**Monks Orchard Residents'
Association
Planning**

Reference:	21/06036/FUL
Amended Drawings:	26 th April 2022
Address:	Land R/O Firsby Avenue & Verdayne Avenue, CR0 8TL
Proposal:	Erection of eight semi-detached houses, together with associated access, car parking and landscaping.
Status:	Awaiting decision
Consultation Expiry Date:	20 May 2022
Case Officer:	Georgina Betts

ADDENDUM

**Design and Access Illustration
of Site Boundary**

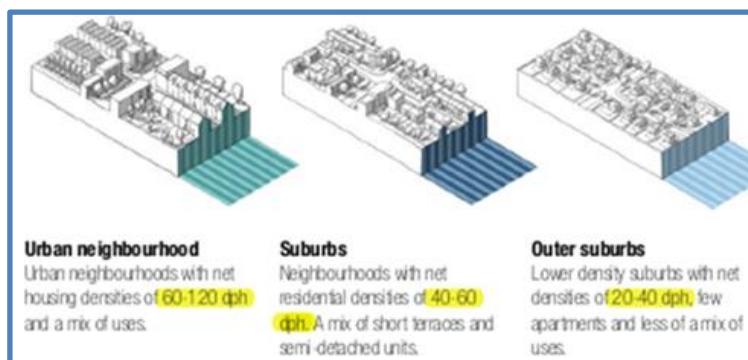
- 1.4 Para 2.1 – Site Location (page 6) of the Design and Access Statement indicates the Site Area is separate from the Access Lane. We see no new evidence or proof that the applicant has gained "ownership" of the **entire site, including the access Lane** now marked in Red on the amended site plan and no statement or confirmation of legal compliance to this **Pre-Application** requirement. There is no change or reissue of the Application Form Item 38 – Ownership Certificates indicating ownership of the Access Lane.

- 1.4.1 This is a contentious issue of the proposal for Residents in Verdayne Avenue and Firsby Avenue. The current Access Drive **users** are 74 to 50 Verdayne Ave., and although the lane at the rear of 2 to 10 (possibly up to 14) Firsby Ave is **NOT** within the Red Line Boundary of the proposal, access to these rear gardens is via the access Lane from Firsby Avenue which is contained within the new site boundary.

- 1.5.1 The **Design and Access Statement** at the **2.3 “Concept Pre-Consultation”** Site Layout shows the East Edge Site boundary to follow the edge of the access lane whereas the new Boundary Outline (Red) shows the East boundary at the rear of numbers **50 to 60 Verdayne Avenue** to have now, in the amended Site Plan **“partially”** absorbed the parcel of land between the rear boundaries of the properties and the east edge of the access lane from **Firsby Avenue** and has up to **4 trees blocking the access**. This difference is of significant concern as ownership of this section could become a **“Ransom Strip”** and preclude ingress and egress from the rear of these properties and access to their garages.

Graphical illustration of Housing Density against an incremental increase in Number of Units for the Site at 0.202ha

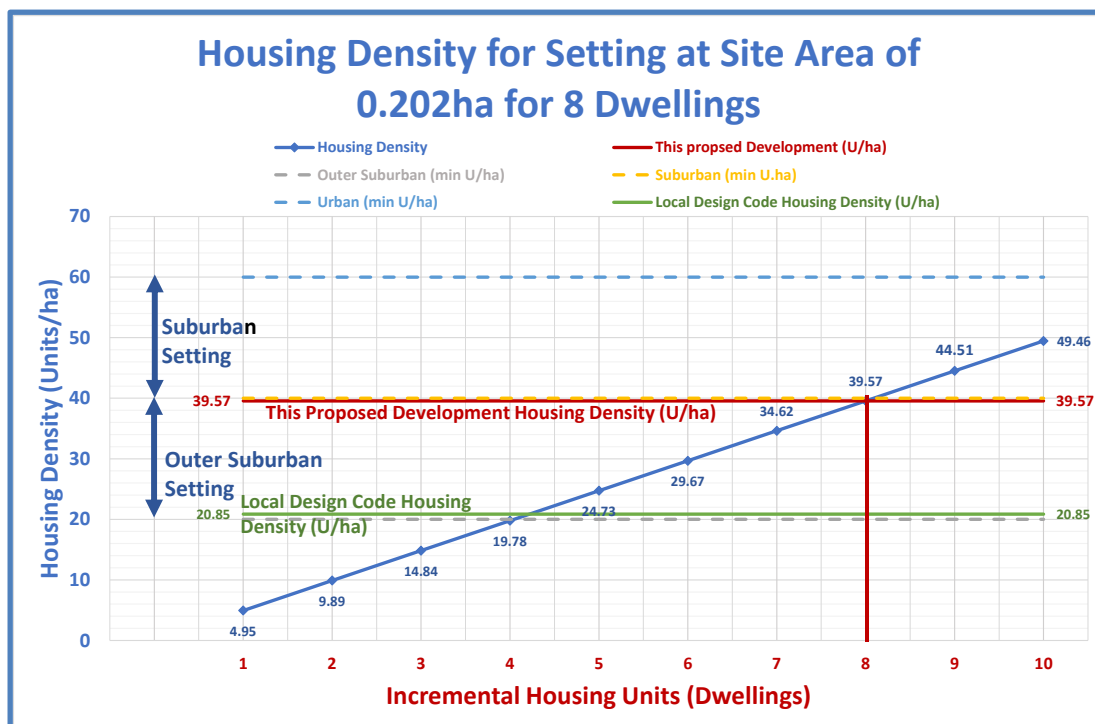
2.4.3 The proposal Housing Density at 39.57units/ha is therefore still just within the limit of the local Setting of “**Outer Suburban**” 20 to 40 **Units/ha**.

Housing Density to Residential Density by National Average Unit Occupancy. Public Transport Accessibility for Residential Density at the Area Type Setting

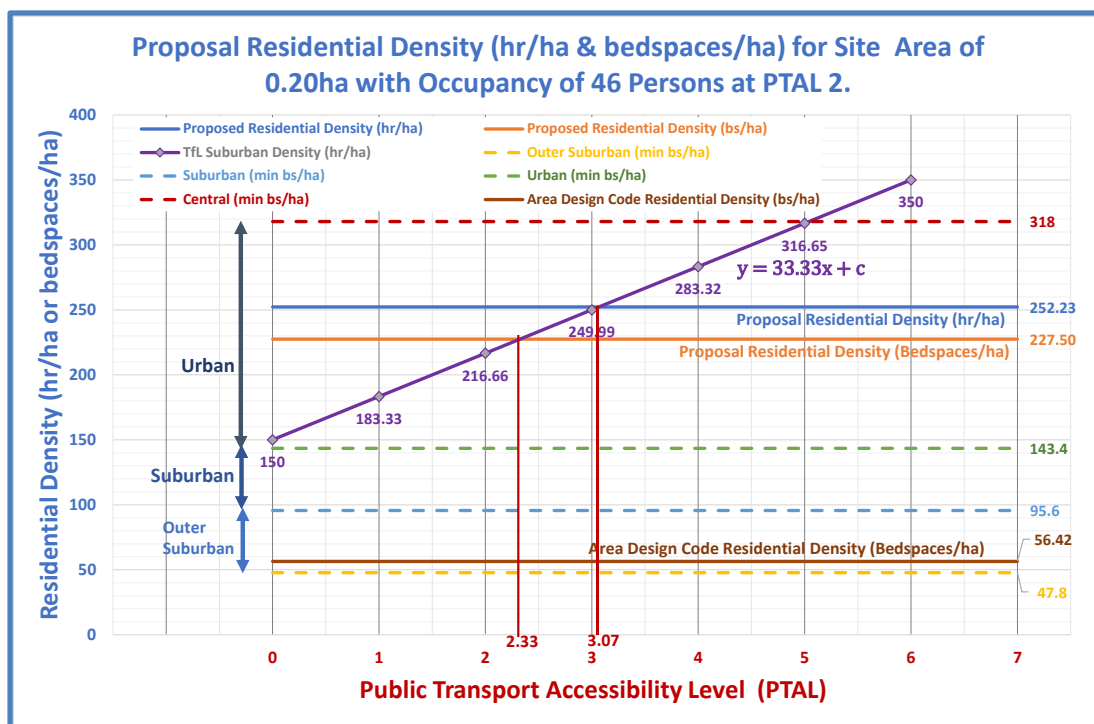
2.6.1 The **Residential Density** analysis shows that the required **PTAL** to support a proposed **Residential Density** of **252.230 hr/ha** would be:

The available **PTAL** of **2** at this location is inadequate if judged on the habitable rooms/ha parameter but within tolerance if judged on the occupants/ha. This assumption is based upon the **ONS** and **Statista** Data of **National Occupancy per Dwelling**.

Google Earth Image 11th April 2019 (American Date format) of site showing Tree Canopy

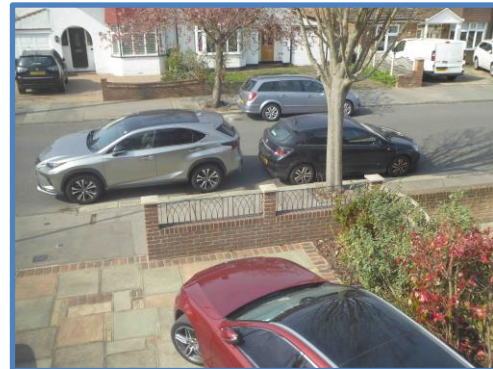
- 3.2 The additional landscaping adjacent to Unit 4 (replacement for previous Unit 5) is beneficial but nowhere near enough to replace the lost vegetation which can be viewed on historical Google Earth images (See below) prior to the site clearance by the previous owner for preparation of subsequent development proposals.

3.5 The Google Earth Image shows the lost lush vegetation and Tree canopy prior to decimation without consent by the owner. It is understood that there were no Tree Preservation Orders on the Site Area.
